Millstone Power Station, Unit No. 2
Response to Request for Additional Information on RR-89-48 for the
Nozzle Inspection Ultrasonic Test Coverage Requirements in Order EA-03-009

Response to Request for Additional Information on RR-89-48 for the
Nozzle Inspection Ultrasonic Test Coverage Requirements in Order EA-03-009

Millstone Power Station, Unit No. 2
Order EA-03-009 Relaxation Request RR-89-48 for the
Nozzle Inspection Ultrasonic Test Coverage Requirements

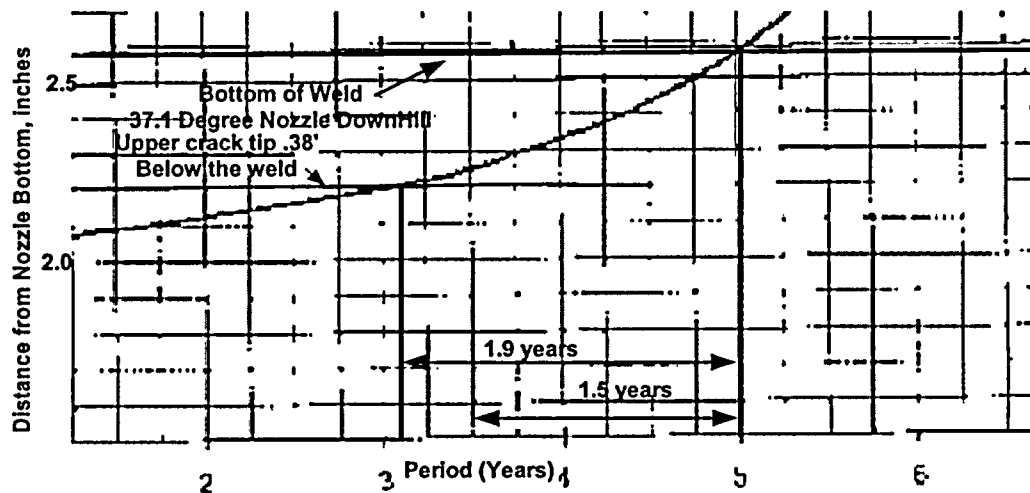
7. *It is unclear how the predicted time for a flaw to grow to a point of contacting the weld of 1.9 years of operation provides adequate margin for the 1.5 years required for the next plant cycle. Describe uncertainties in this calculation (e.g., stress levels, crack growth rate, etc.) and the uncertainty in the result.*

The 26 percent margin on the time for a postulated flaw to reach the specified acceptance limit is considered adequate. The recommended staff guidelines referenced in footnote 4 of DNC's request RR-89-48 does not require a margin on time to reach the bottom of the weld. Uncertainty in the flaw propagation time to the acceptance limit is addressed by the margin inherent in the propagation limit itself, since there is no structural integrity or leakage issue until the flaw has

progressed well beyond the limit. The primary conservatism is that the analysis does not include any time for a crack to grow through the weld. Until a crack grows through the weld, a leak cannot occur.

For Millstone there is an additional conservatism relative to the recommended guidelines in that the CEDM nozzles fabricated from Huntington Alloy materials are likely to have a significantly lower flaw propagation rate than that recommended by the guidelines and MRP-55 Rev. 1. In Table 5-3 of the MRP-55, five Huntington alloy heats (comprising 30 specimens) are listed and for these, the maximum mean *alpha* coefficient in the growth formula is 1.37E-12 as compared to the MRP-55 value of 2.67E-12. None of the Huntington materials exceeds the MRP-55 value. Since it is considered that the Huntington test data are indicative of the expected results for the Millstone nozzle materials, the mean growth rate for the Millstone nozzle materials is about half the MRP-55 recommended value, resulting in a significant margin in crack growth duration to reach the acceptable limit.

The major inputs to calculation of time to grow to the weld are discussed below. More information can also be found in chapters 5 and 6 of the submitted WCAP-15813-P.

- Stress analysis results – The stress analysis was performed with a three dimensional finite element model. The weld was simulated by two weld passes. The results are expected to be a best estimate of the stress with very small uncertainties.
- Flaw sizing – the flaw sizing is postulated so there is no uncertainty. Postulating a through-wall flaw conservatively bounds any flaw that could exist in the head penetration.
- Material yield strength – The yield strength has an effect on crack initiation time but has been shown to have no impact on the Primary Water Stress Corrosion Cracking (PWSCC) growth rate.⁽⁵⁾

SECTION VIEW B-B
Q CLOSURE HEAD LOOKING NORTHEAST
AT NOZZLES 14, 34 & 59
SCALE: NONE

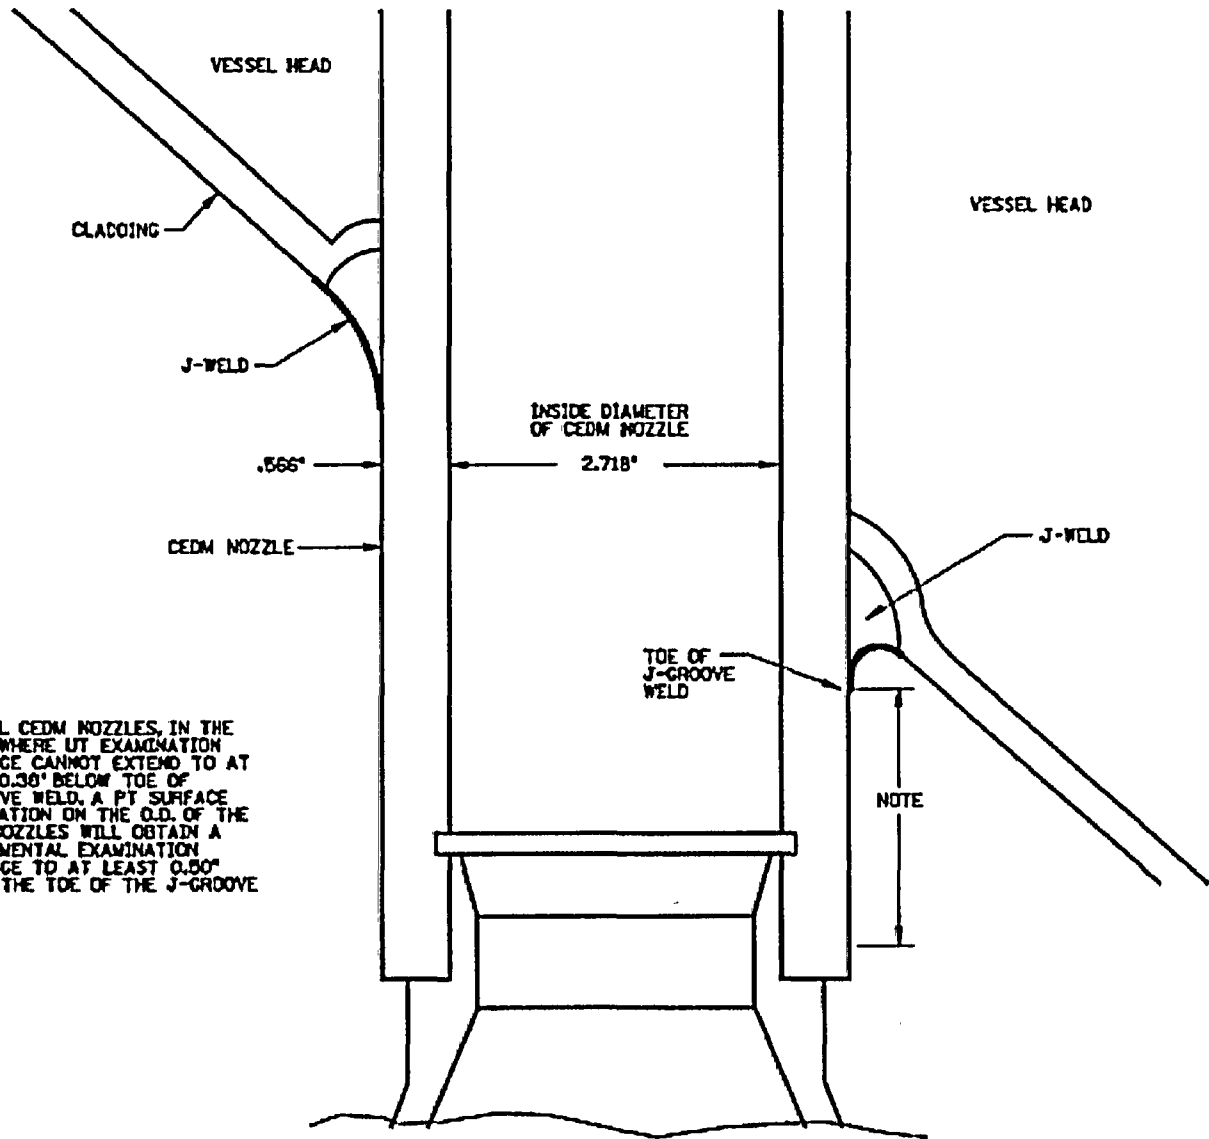
2. *Provide the scope of the PT surface examinations, and the flaw tolerance on each CEDM penetration. What is the proposed area to be examined? Will the examination be 360 degrees around the nozzle? Provide a drawing or drawings showing the area to be examined by PT. Will the surface examination be performed to the bottom of the nozzle?*

UT examination coverage obtained is a full 360° around the nozzle. The proposed area to be PT examined will be 180° of the nozzle Outside Diameter (OD) centered on the downhill side, (see attached Figure, Section View B-B), from the toe of the weld at the lowest point on the weld, extending down to cover approximately 3/4 inches of the nozzle base material. This examination will overlap the area that was examined ultrasonically and extend below to obtain the desired coverage. An attempt will be made to avoid examining the end of the nozzle, (approximately 1/4 inches from the bottom), because the bleed-out of the penetrant from the mating surface between the nozzle end and funnel could mask the area of interest.

Performing a liquid penetrant examination on the nozzle base material on the uphill side of the nozzle, would result in an increase in radiological exposure, (approximately double), without a commensurate increase in the level of quality or safety for this inspection. A liquid penetrant exam of the uphill side would involve climbing down the ladder, moving the ladder, and climbing back up the ladder to perform the additional PT on that side of the nozzle.

NOTE:
FOR ALL CEDM NOZZLES, IN THE AREAS WHERE UT EXAMINATION COVERAGE CANNOT EXTEND TO AT LEAST 0.30' BELOW TOE OF J-GROOVE WELD, A PT SURFACE EXAMINATION ON THE O.D. OF THE CEDM NOZZLES WILL OBTAIN A SUPPLEMENTAL EXAMINATION COVERAGE TO AT LEAST 0.50' BELOW THE TOE OF THE J-GROOVE WELD.

PLAN VIEW A-A
(MP2 REACTOR VESSEL CLOSURE HEAD)
NORTH
SCALE: NONE

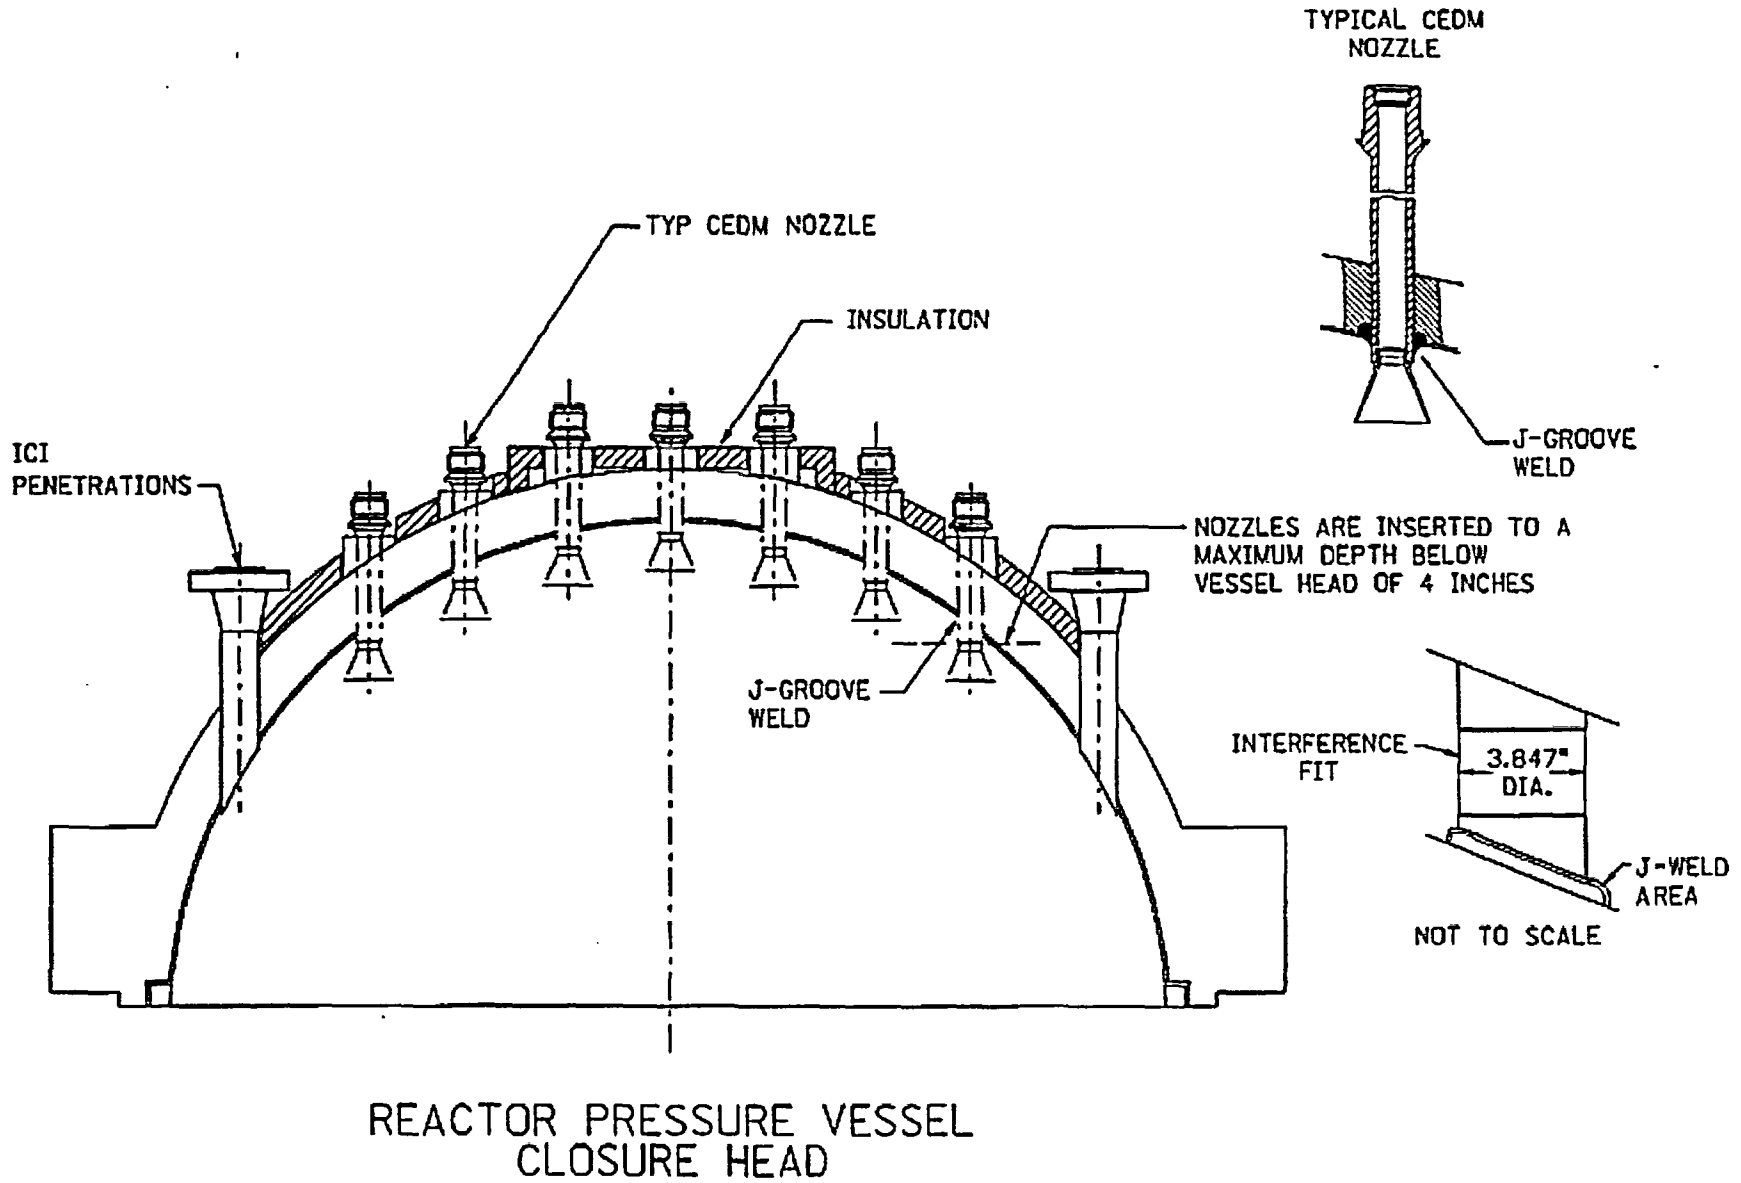
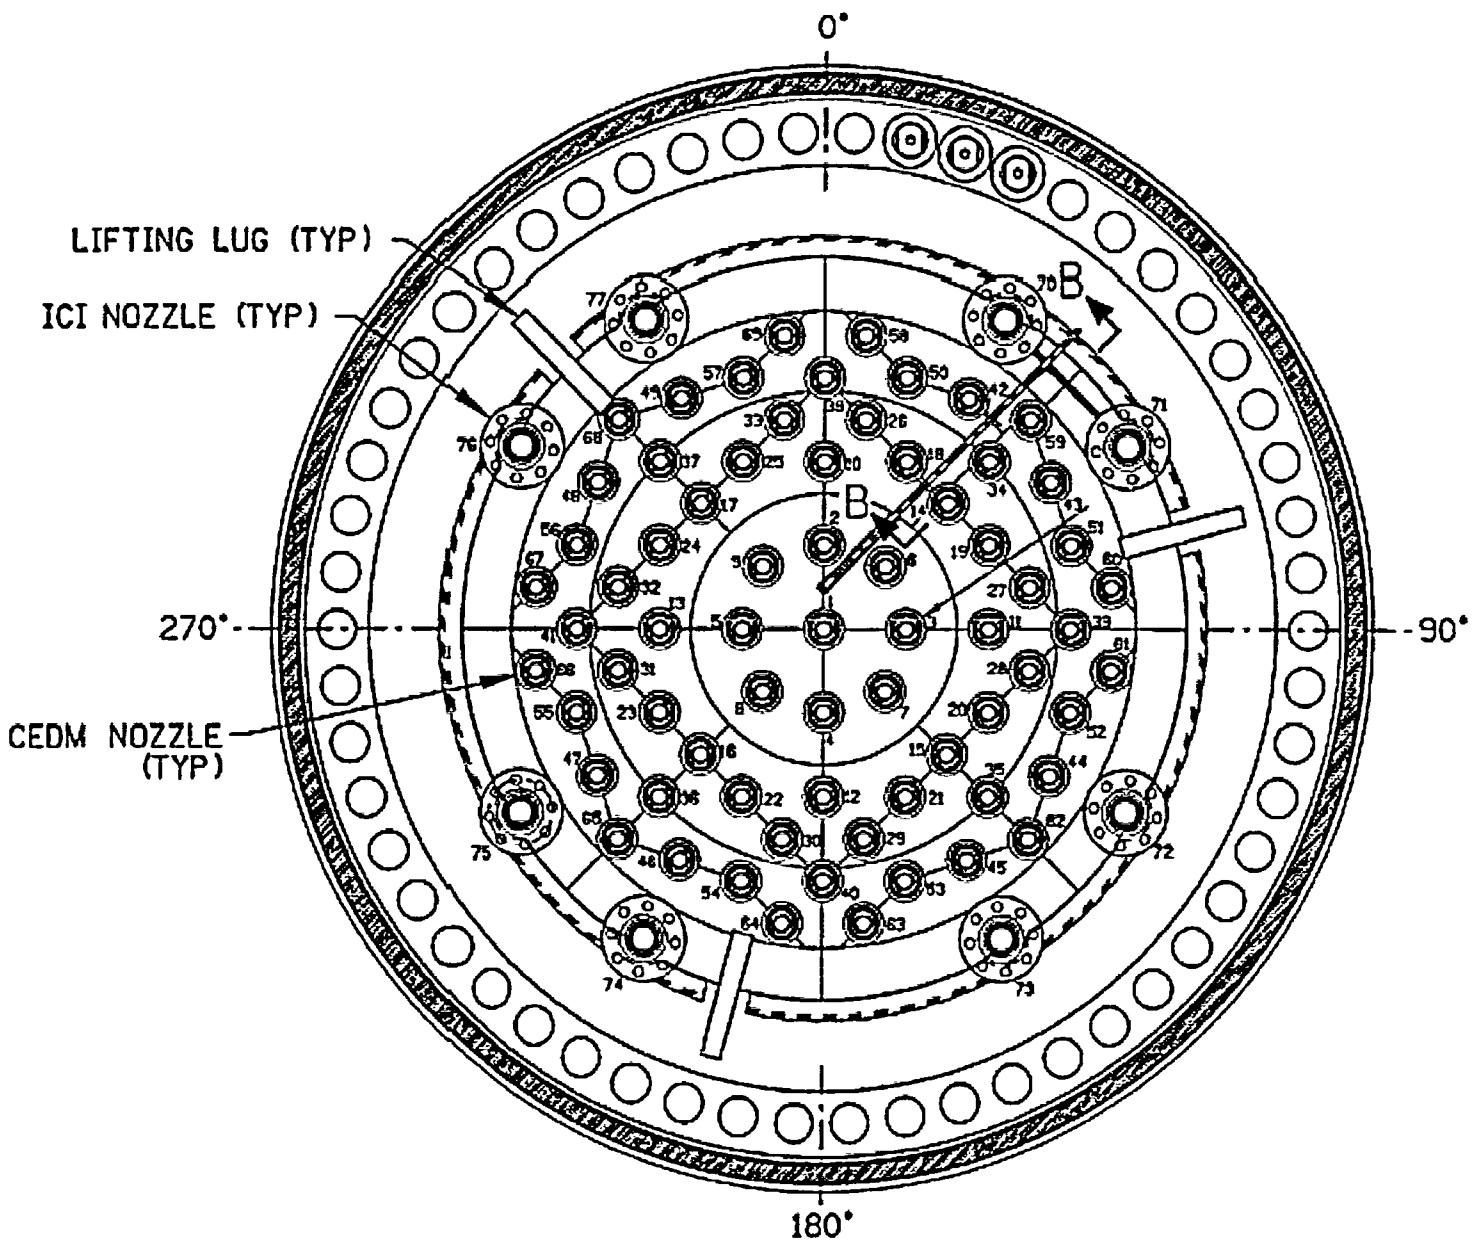
9. *Provide a cross sectional figure of the head and penetrations showing how far each penetration protrudes below the bottom surface of the head using as built dimensions and considering the UT results from the last inspection. Are there any photos from the last or previous outages? If so provide any photos that show how far the penetrations protrude below the head.*

Photos have not been included. The CEDM nozzle arrangement is described by the figures provided in the balance of this Attachment.
